Committee of Experts on the Transport of Dangerous Goods and on the Globally Harmonized System of Classification and Labelling of Chemicals

Sub-Committee of Experts on the Transport of Dangerous Goods

Lithium batteries and hazard communication – Comments on ST/SG/AC.10/C.3/2014/89

Transmitted by the International Air Transport Association (IATA)

Fig. XXX

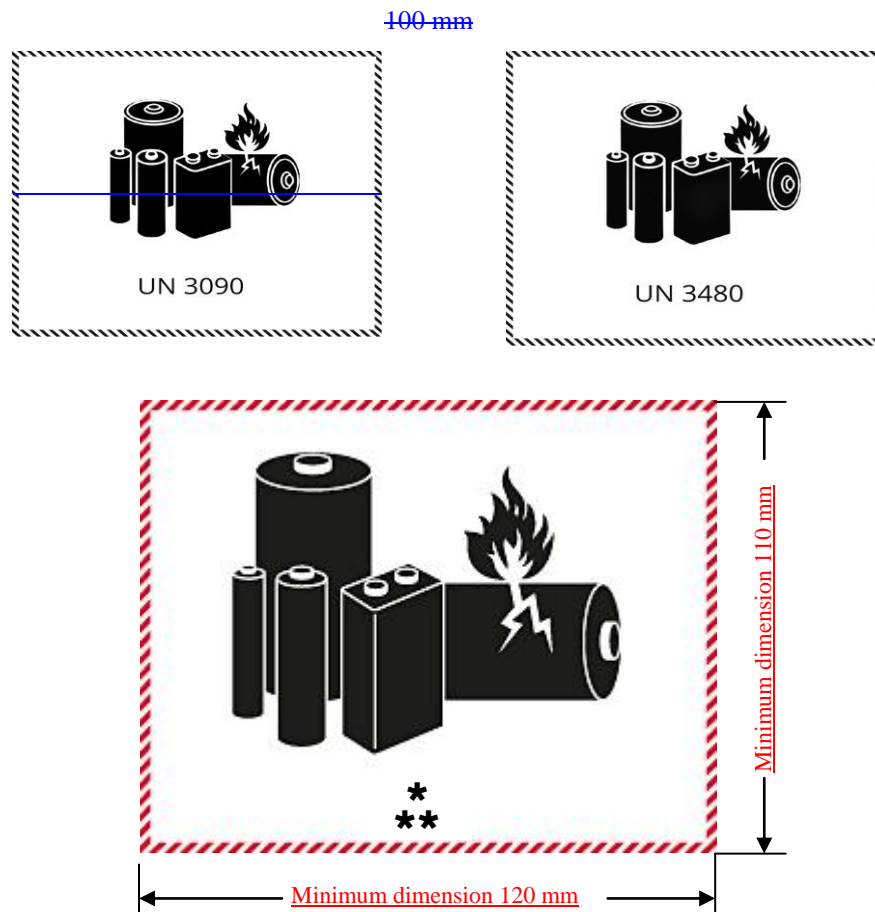
6. Based on the decision by the ICAO Dangerous Goods Panel to specify minimum sizes and the widespread use of the air transport “label”, IATA requests that the Subcommittee consider aligning the size of the lithium battery mark with that of the “label” required by the ICAO Technical Instructions.

7. IATA also supports the proposal in informal document INF.28 from PRBA and RECHARGE to include provision for the telephone number on the lithium battery mark to meet the requirements of subparagraph (f) of Special Provision 188.

5.2.1.9.2 The mark shall indicate the UN number, 'UN 3090' for lithium metal batteries or 'UN 3480' for lithium ion batteries. Where the lithium batteries are contained in, or packed with, equipment, the UN number 'UN 3091' or 'UN 3481' should shall be substituted for the UN numbers shown below indicated. In cases of a mixed load of batteries and batteries in equipment, it is sufficient to display the battery label only all applicable UN numbers shall be indicated.

* Place for UN number

**** Place for telephone number if not shown elsewhere on the package**

The mark shall be in the form of a rectangle with hatched edging. The dimensions shall be ~~[100 mm x 80 mm]~~ a minimum of 120 mm wide x 110 mm high and the minimum width of the hatching shall be 5 mm. The symbol (group of batteries, one damaged and emitting flame, over the UN number for lithium ion or lithium metal batteries or cells) shall be black on white. The hatching shall be red. If the size of the package so requires, the dimensions/line thickness may be reduced to not less than 105 mm wide x 74 mm high, ~~provided the marking remains clearly visible.~~
